Access Compliance Report

Public Rights-of-Way

(Curb Ramps)

Intersection ID: 43653	Main Street: HUNTINGTON_MEADOW_LN	Cross Street: TAGGERT_TRAIL_DR	Location: SE
ADA ID: B11951551420	Ramp Type: Perp	Initial Pass/Fail: Fail	Overall Compliance: No
Severity Score: 21.25			
Codes/Mitigation Info/Possible Solution		Field Measurements/Component Compliance

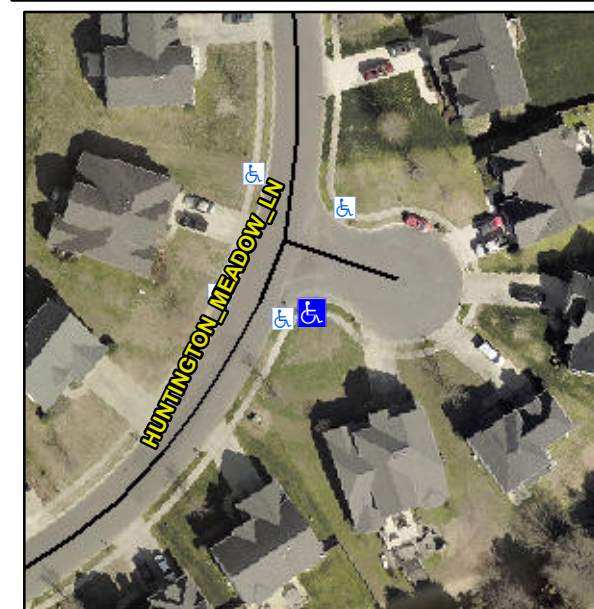
Not Found, R304.5.1, R304.2.2

Compliance	Description	Data	Compliance	Description	Data
N/A	Ramp Length (in)	48.0	No	Ramp Slope (%)	8.8
No	Ramp Width (in)	46.0	Yes	Ramp XSlope (%)	1.0
N/A	Flare Type LT	N/A	N/A	Flare Type RT	N/A
N/A	Flare Slope LT (%)	N/A	N/A	Flare Slope RT (%)	N/A
N/A	Flare Traversable LT?	N/A	N/A	Flare Traversable RT?	N/A
N/A	Landing Length (in)	N/A	N/A	DWS Provided?	N/A
N/A	Landing Width (in)	N/A	N/A	DWS Contrast?	N/A
N/A	Landing Slope (%)	N/A	N/A	DWS Length (in)	N/A
N/A	Landing X Slope (%)	N/A	N/A	DWS Full Width?	N/A
N/A	Landing Curb? (Y/N)	N/A	N/A	DWS Offset (in)	N/A
N/A	Shared Landing?	N/A			
N/A	Gutter Ponding?	N/A	N/A	Gutter Slope (%)	N/A
N/A	Gutter Lip Ht (in)	N/A	N/A	Gutter X Slope (%)	N/A
N/A	Painted X Walk1?	No	N/A	Painted X Walk2?	N/A
	X Walk 1 Direction	To NE		X Walk 2 Direction	N/A
N/A	X Walk 1 Width (in)	N/A	N/A	X Walk 2 Width (in)	N/A
	X Walk 1 Slope (%)	3.7		X Walk 2 Slope (%)	N/A
	X Walk 1 X Slope (%)	0.1		X Walk 2 X Slope (%)	N/A

Remove & Replace Entire Ramp.
